RE: Compliance Assistance Offer
North Florida Rock
FL0980722
Jackson County

FLORIDA DEPARTMENT OF ENVIRONMENTAL PROTECTION
WASTEWATER COMPLIANCE INSPECTION REPORT

Site Report

Image #:	1
Photo Description:	Swallet before discharging into Chipola River
Photo Location:	30°38'15.4"N 85°10'07.6"W

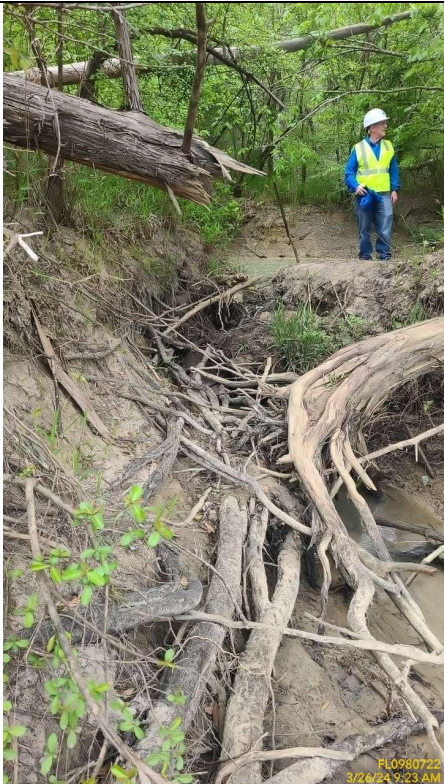
- 10.1 Deficiency:** Weir not functioning as per permit requirements. (See photos # 14 & 15)
Rule/Permit Reference: Phase 1 Language currently states that the settling pond outfall consists of an 8-foot broad-crested weir with concrete block agitators on discharge slope of weir with overland flow to discharge point at surface level.
Corrective Action: Please provide reasonable assurance that the pending permit modification will resolve this deficiency.
- 10.2 Deficiency:** Sinking stream "swallet" is not currently 45 feet from the Chipola River

and now has created a natural outfall also linked to the river. (See photos #1-6)

Corrective Action: Please provide reasonable assurance that the pending permit modification will resolve this deficiency.

Image #:	16
Photo Description:	DO Results
Photo Location:	30°38'14.9"N 85°10'18.6"W

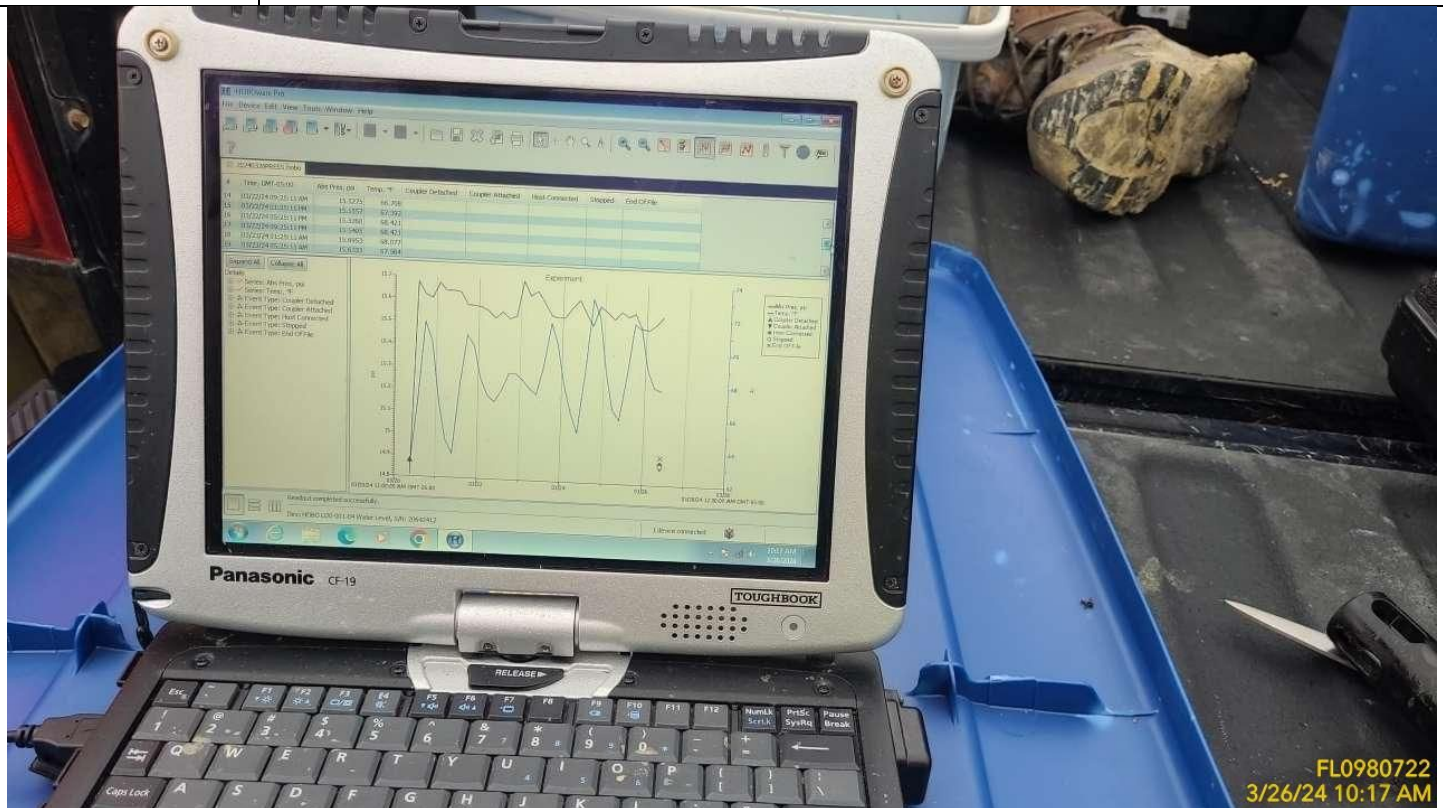
- 4.1 Observation: Multiple parameters tested during inspection were all within permit limits. February 2024 flow (1.36 mgd average); DO (8.74-12.12 mg/L); pH (7.5); Turbidity (10.8 NTU's) (See photos #13 & 16)
Additional Comments: Icarus Ecological Services conducts the sampling for the facility.
